Memo

To: Bendigo-Ophir Gold Project Expert Panel **Cc:** Environmental Protection Authority

Subject: **Joint Response to Panel Request for Information 4 – Geology, Geotech, Engineering**

Figure F3: Expected Case – Operational Conditions

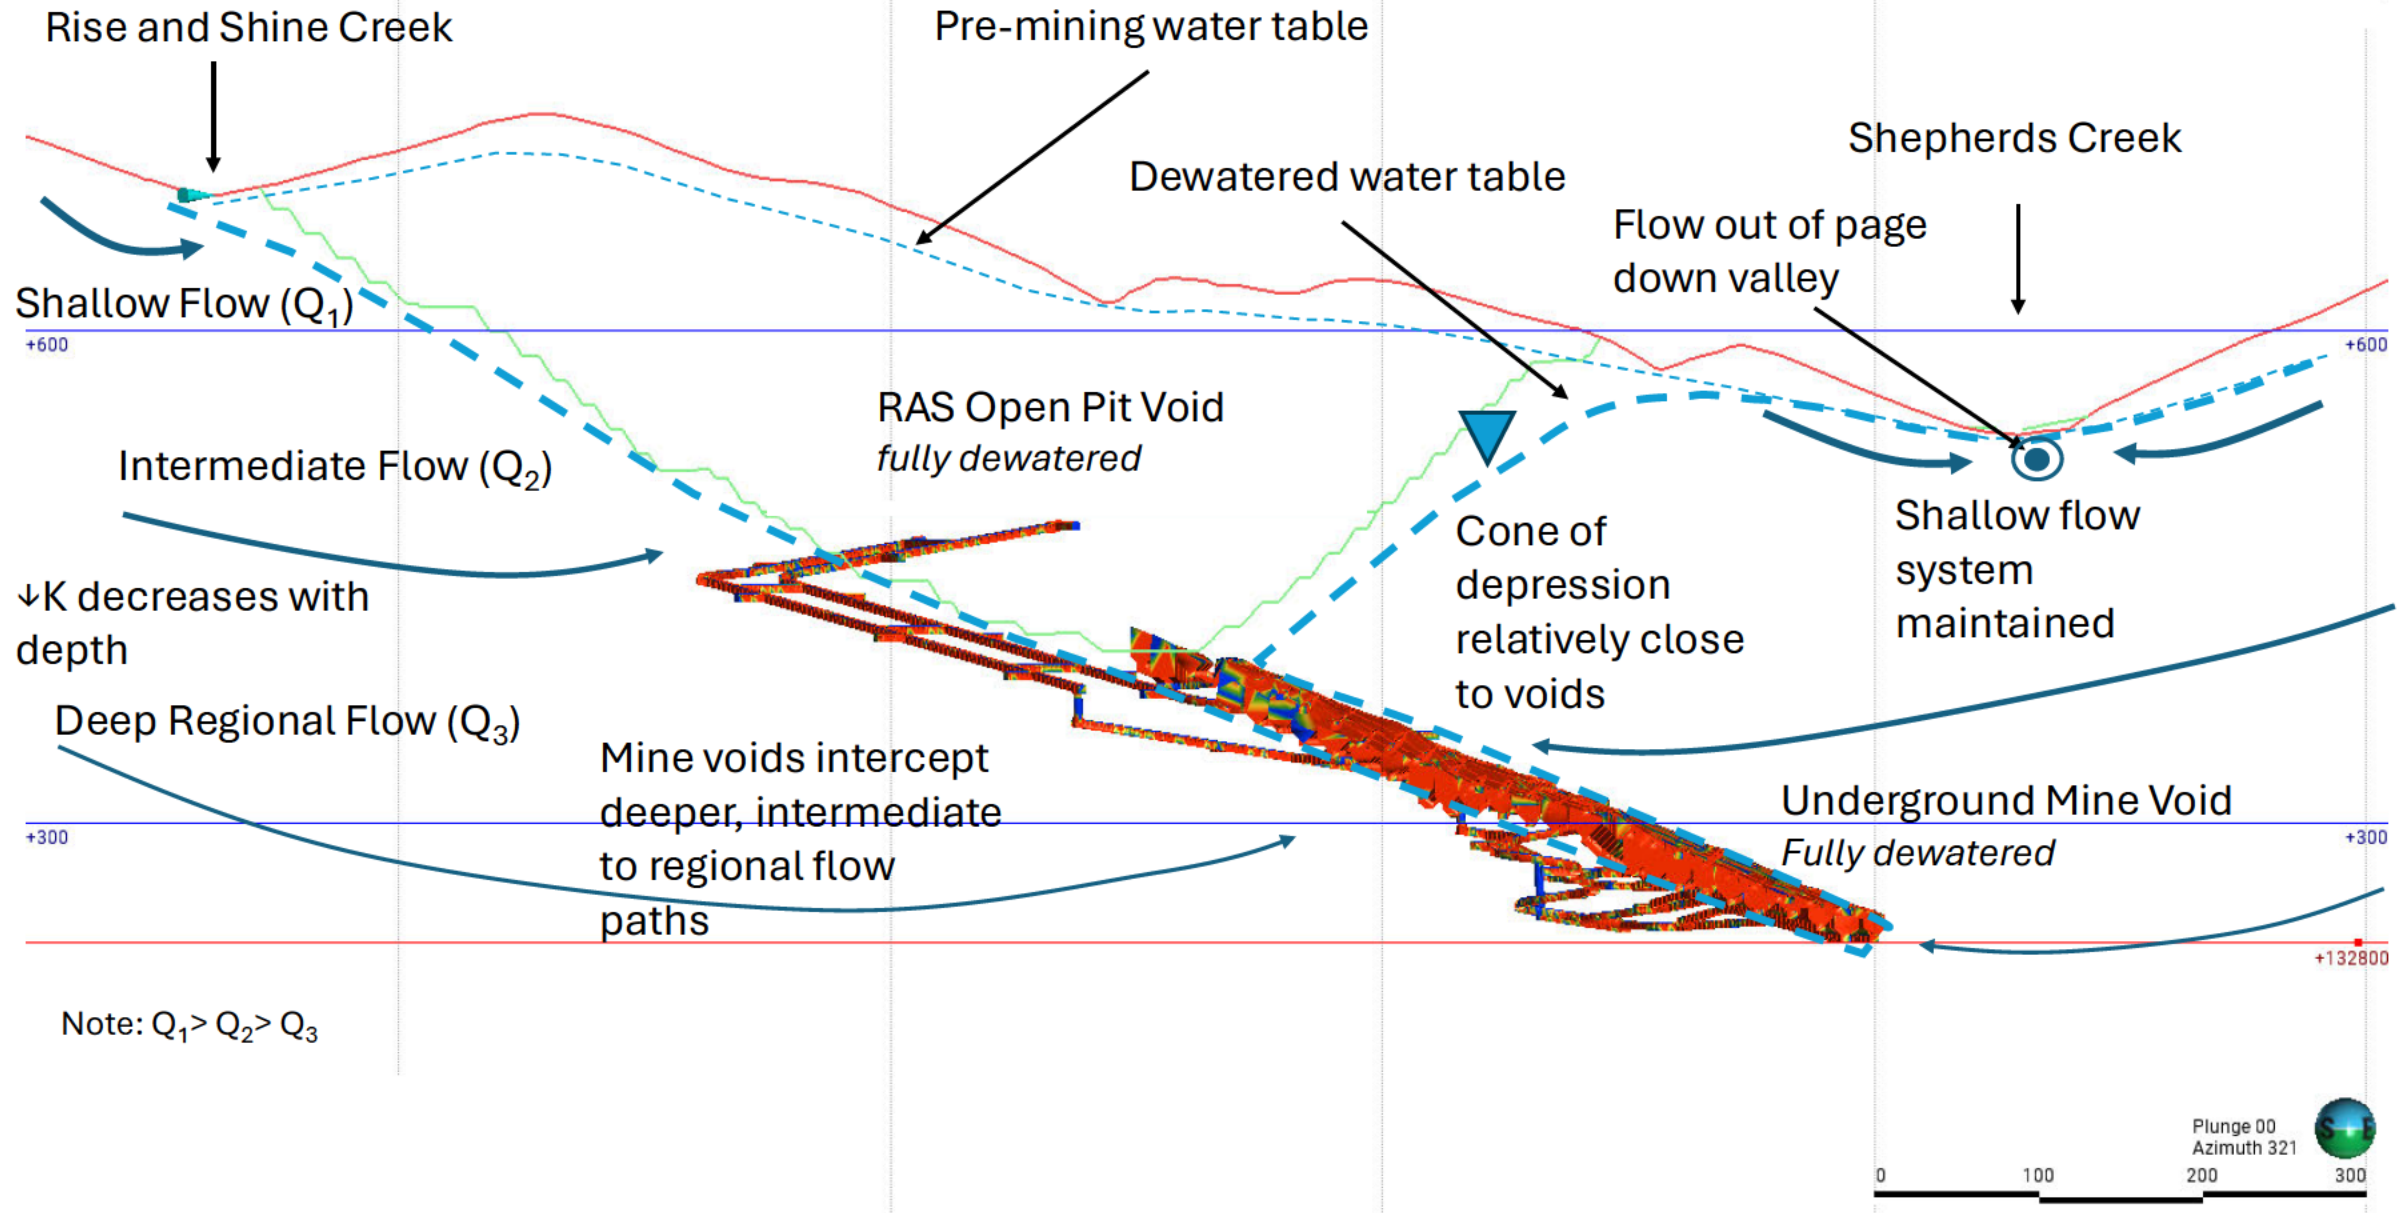
88. The relatively tight and low hydraulic conductivity schist bedrock can be expected to restrict the propagation of drawdown relatively close to the pits. This conceptualisation is consistent with the 3D groundwater modelling completed by KSL²² where results suggest a local flow divide is maintained between the RAS Pit and Shepherds Creek at the life of mine pit void. This condition for operations is presented conceptually in Figure F3, termed the Expected Case.

Figure F4: Unlikely Case – Operational Conditions

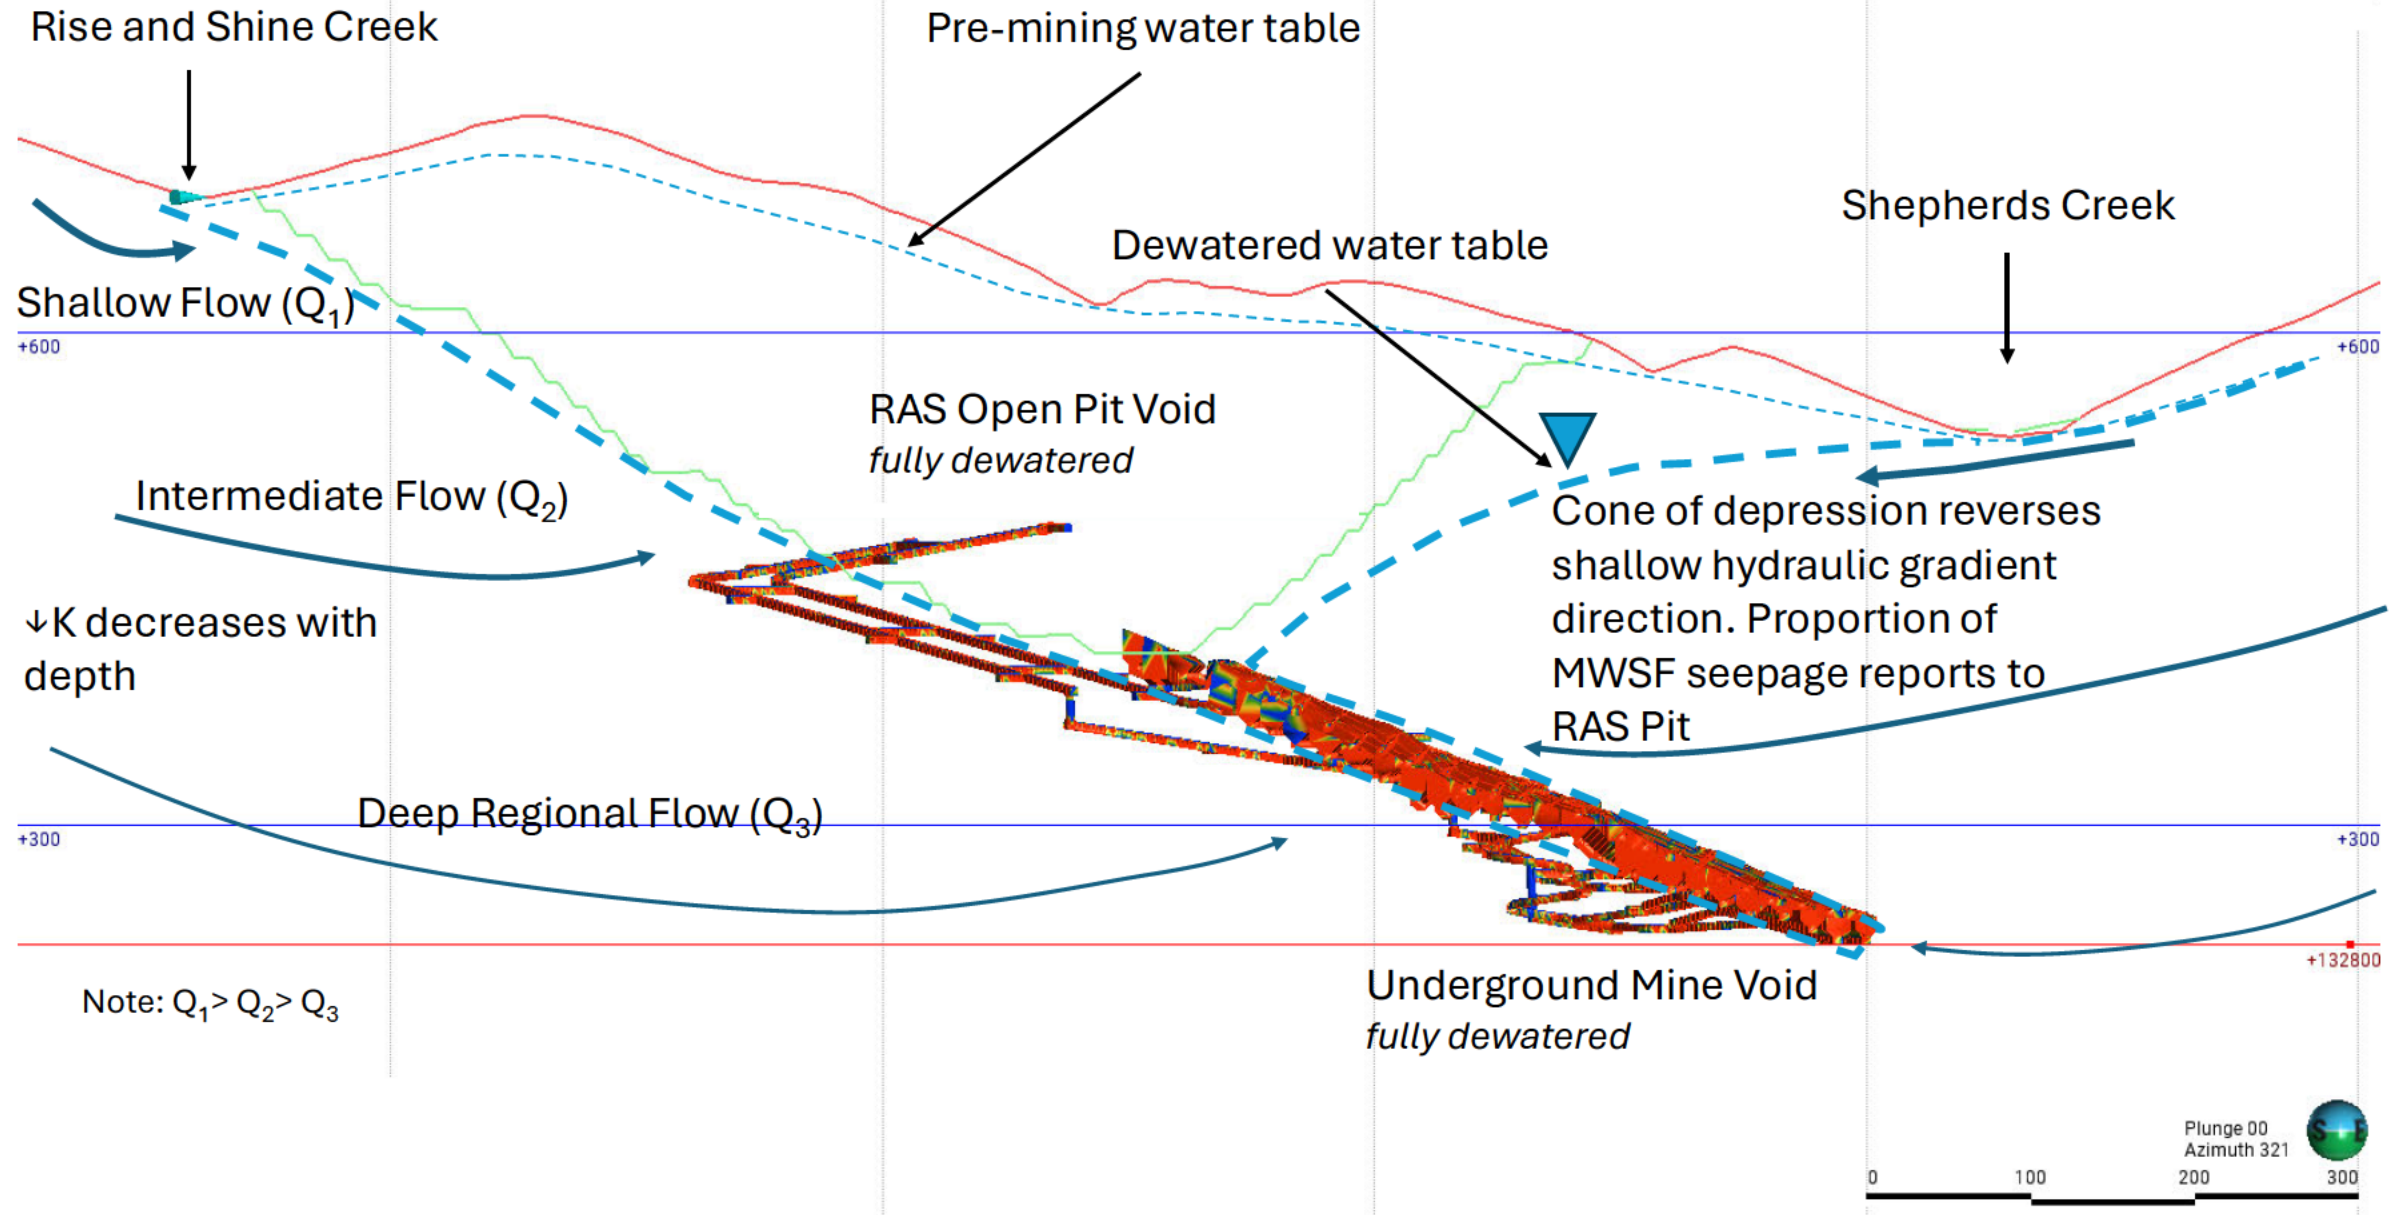
89. If, in the unlikely event, drawdown associated mine void dewatering (either open pit or underground) were to alter the proportion MWSF seepage collection, with or without localised changes in the schist rock mass hydraulic properties due to relaxation of the schist rock mass, these voids, the RAS Pit and Underground will act as groundwater sinks, effectively intercepting any uncaptured seepage migrating in deeper schist bedrock past primary seepage collections systems (e.g., the Shepherds ELF toe bund and underdrain). This is conceptualised in Figure F4 for Operations, termed here as

Figure F5: Expected Case– Post-closure Conditions

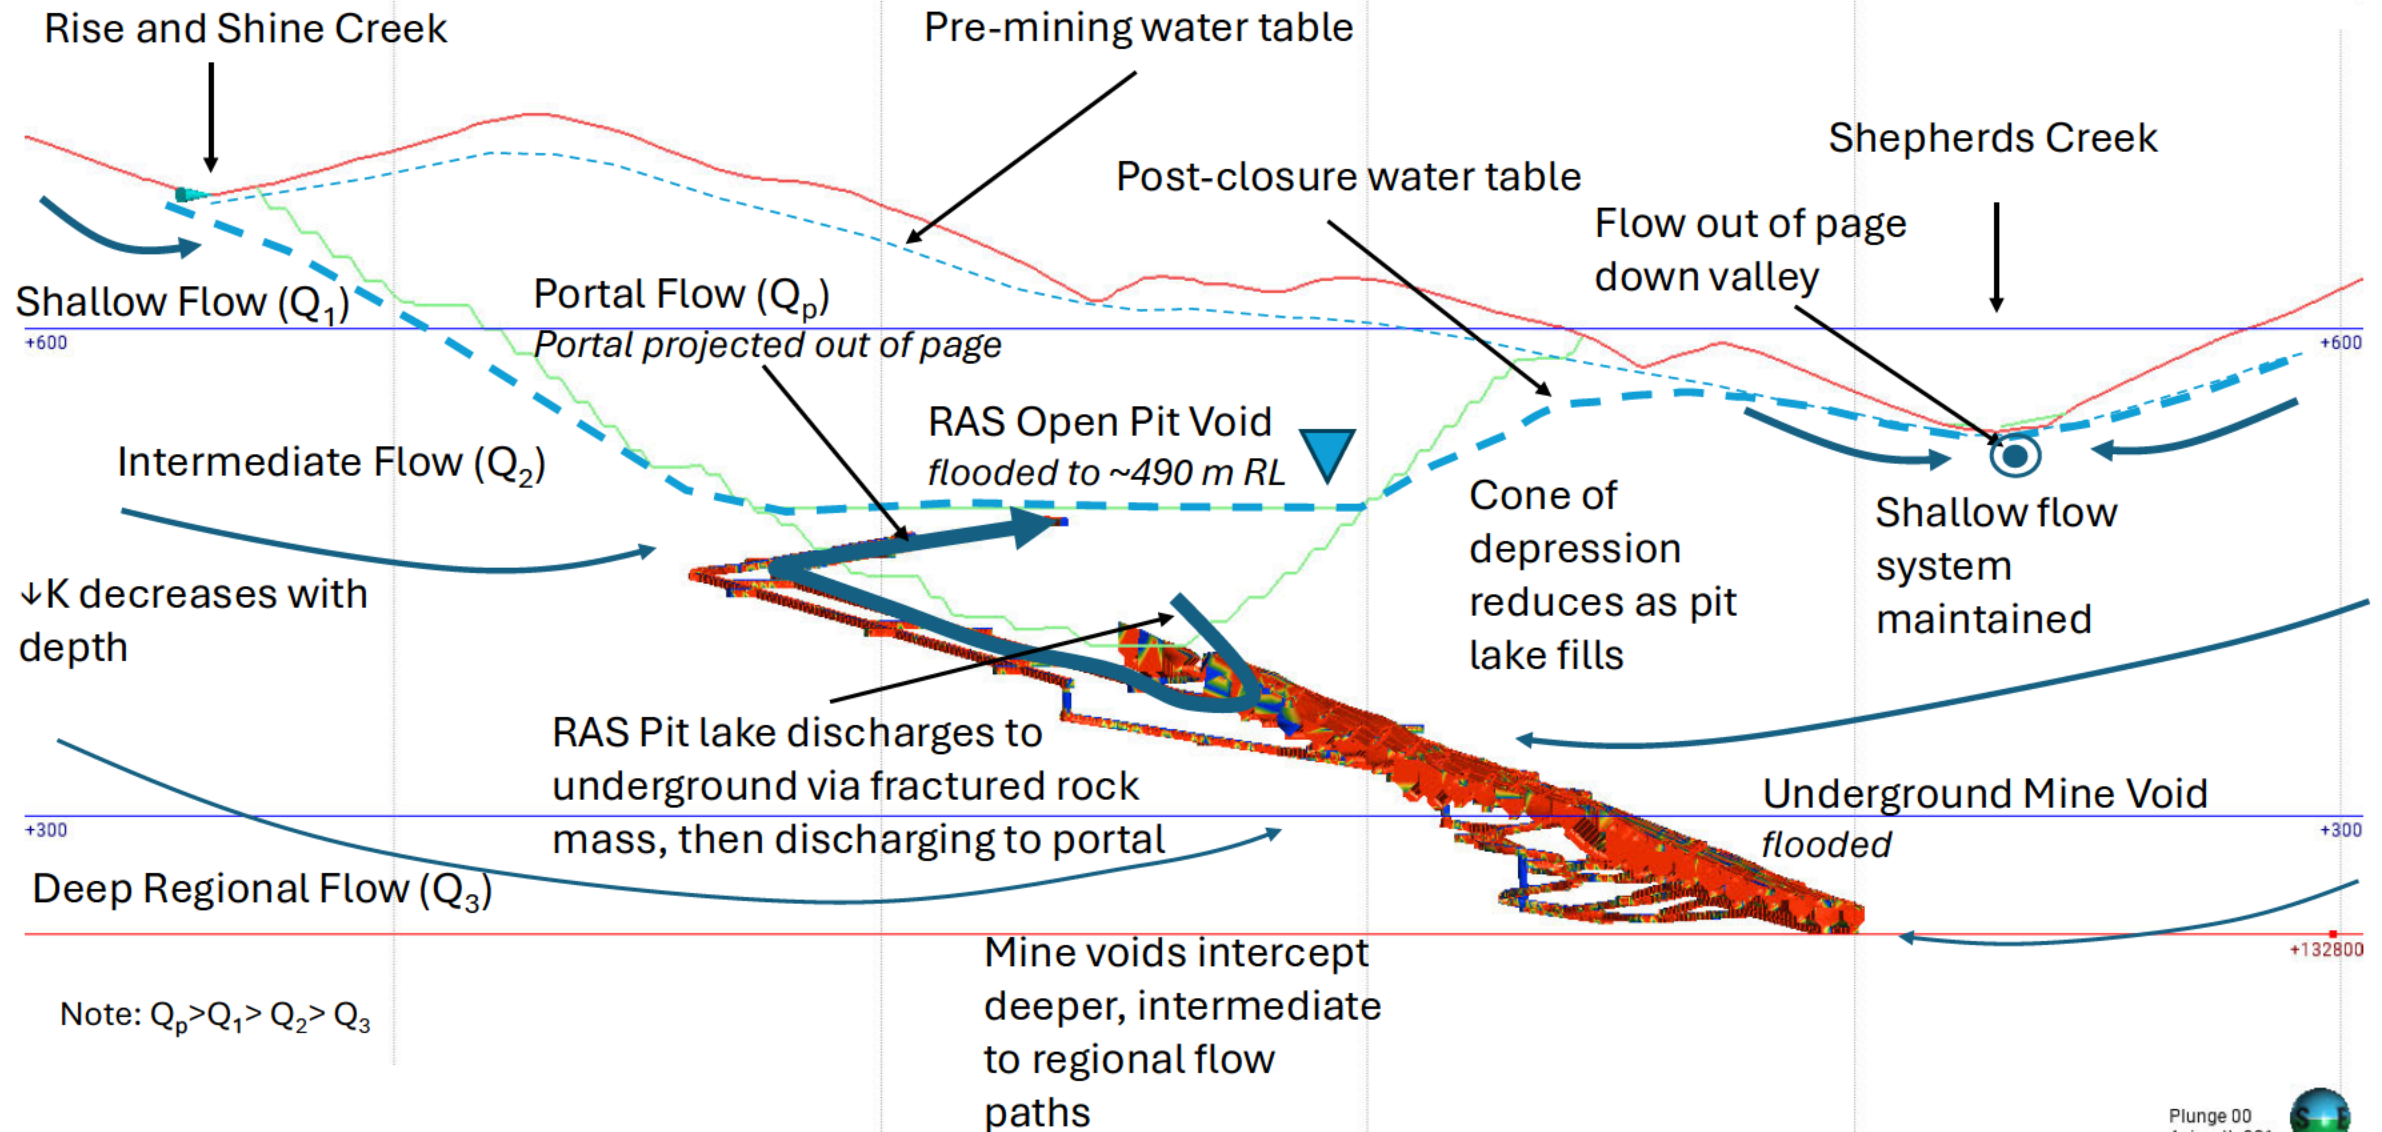
92. For the Expected Case, under Post-closure conditions, the shallow flow system important for seepage collection would be maintained consistent with the Operational Conditions (Figure F5).
